Access Compliance Report

Public Rights-of-Way

(Curb Ramps)

Intersection ID: 12548	Main Street: W MARTIN LUTHER KING JR BV	Access Street: S TRYON ST	Location: W
ADA ID: 3CFA6189B3D0	Ramp Type: PerpDiag	Initial Pass/Fail: Fail	Overall Compliance: No
Codes/Mitigation Info/Possible Solution		Field Measurements/Component Compliance	
Severity Score: 13.75

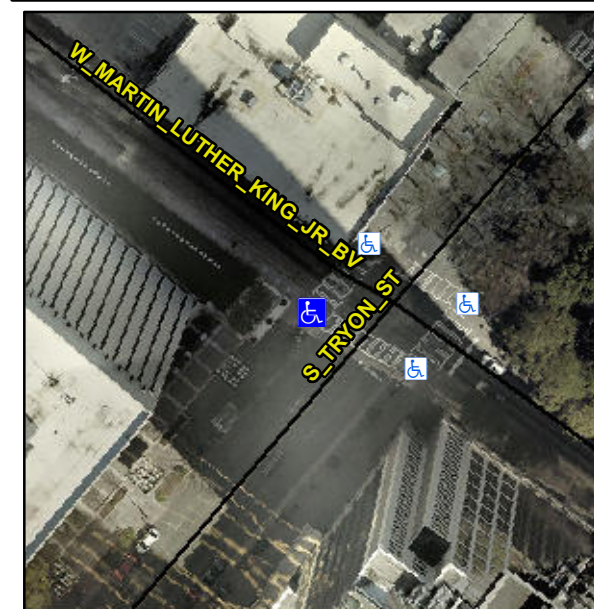
R304.2.2, R304.5.3

Compliance	Description	Data	Compliance	Description	Data
N/A	Ramp Length (in)	74.0	No	Ramp Slope (%)	8.4
Yes	Ramp Width (in)	65.0	No	Ramp XSlope (%)	4.3
N/A	Flare Type LT	N/A	N/A	Flare Type RT	N/A
N/A	Flare Slope LT (%)	N/A	N/A	Flare Slope RT (%)	N/A
N/A	Flare Traversable LT?	N/A	N/A	Flare Traversable RT?	N/A
N/A	Landing Length (in)	N/A	N/A	DWS Provided?	N/A
N/A	Landing Width (in)	N/A	N/A	DWS Contrast?	N/A
N/A	Landing Slope (%)	N/A	N/A	DWS Length (in)	N/A
N/A	Landing X Slope (%)	N/A	N/A	DWS Full Width?	N/A
N/A	Landing Curb? (Y/N)	N/A	N/A	DWS Offset (in)	N/A
N/A	Shared Landing?	N/A			
N/A	Gutter Ponding?	N/A	N/A	Gutter Slope (%)	N/A
N/A	Gutter Lip Ht (in)	N/A	N/A	Gutter X Slope (%)	N/A
N/A	Painted X Walk1?	Yes	N/A	Painted X Walk2?	Yes
	X Walk 1 Direction	To SE		X Walk 2 Direction	To NE
N/A	X Walk 1 Width (in)	108.0	N/A	X Walk 2 Width (in)	108.0
	X Walk 1 Slope (%)	1.6		X Walk 2 Slope (%)	N/A
	X Walk 1 X Slope (%)	0.8		X Walk 2 X Slope (%)	N/A

Remove & Replace Curb Ramp With Two New Directional Ramps or Equivalent.
